Assessing new nuclear power station designs

Generic design assessment of Hitachi-GE Nuclear Energy Limited's UK Advanced Boiling Water Reactor

Decision document

December 2017

Figure 8.1: Diagram of gaseous, liquid and solid waste arisings within the UK ABWR (from Hitachi-GE's Summary of the Generic Environmental Permit Applications GA91-9901-0019-00001 Revision H).

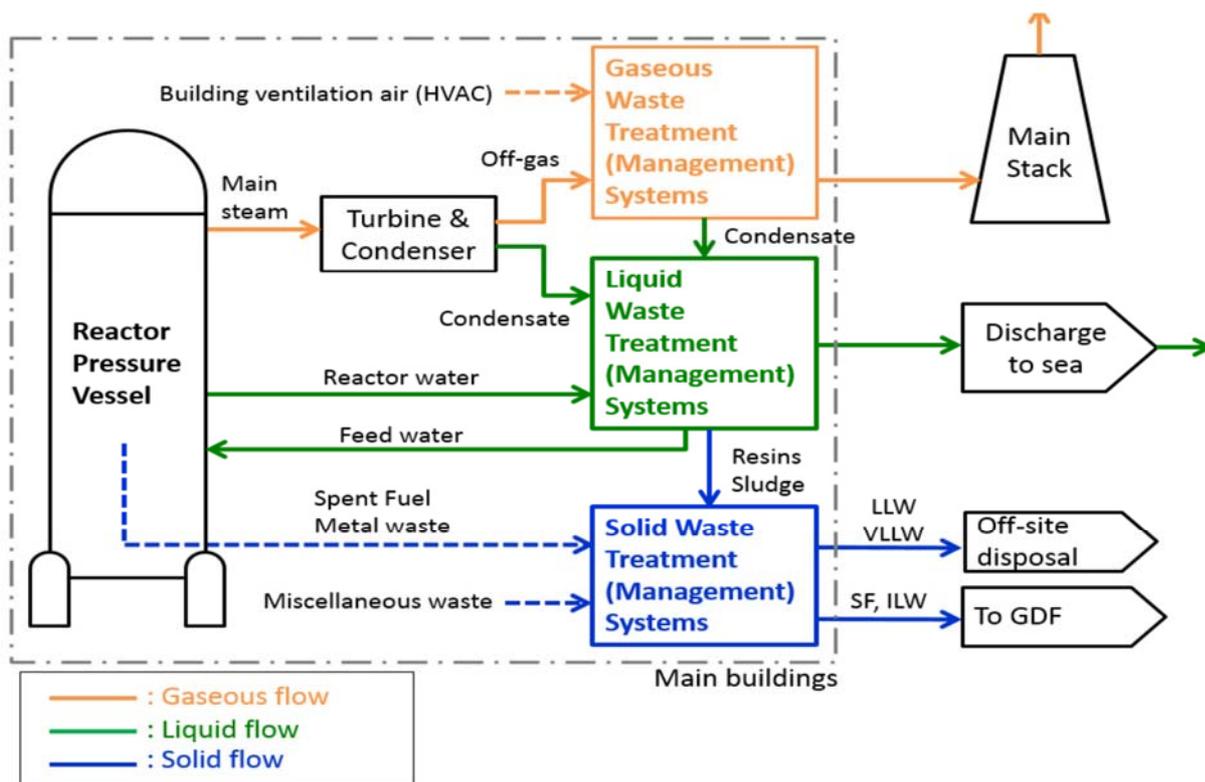
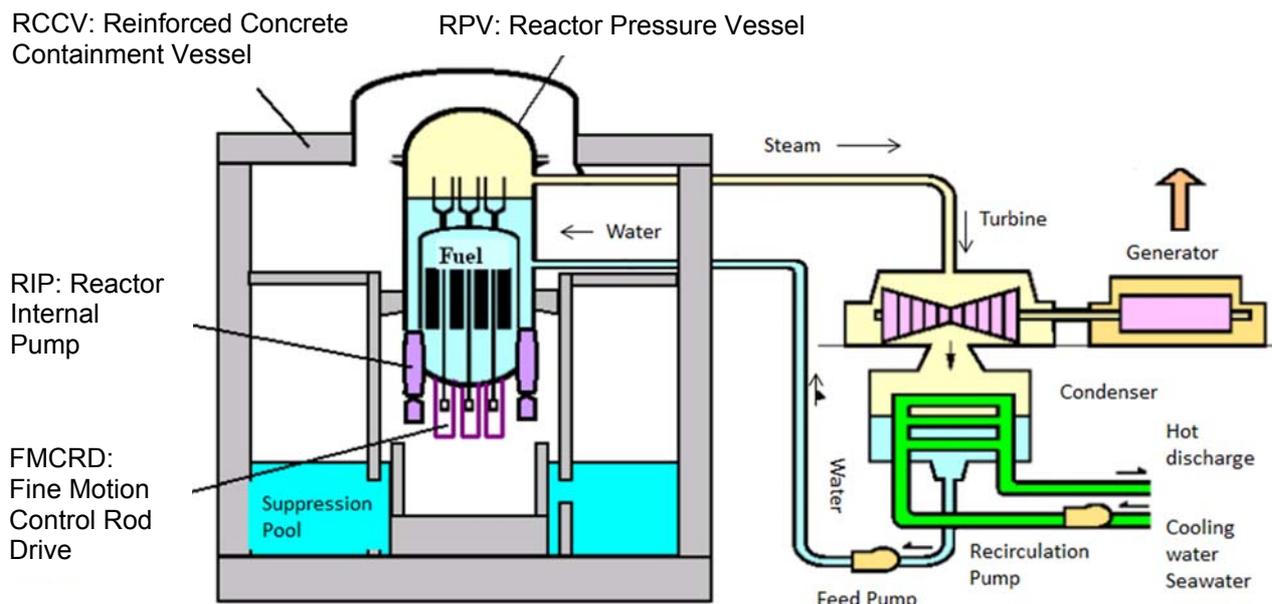
<p>c The respondent noted that reference is made to a stack and yet neither Fig 8.1 or 3.1 or the front of the document show a stack and request that this is</p>	<p>The illustration used on the cover of our documents was provided to us by Hitachi-GE. It's a high-level conceptual early illustration and is not reflective of the site-specific plans. We acknowledge that it does not show detail.</p>	<p>N/A</p>
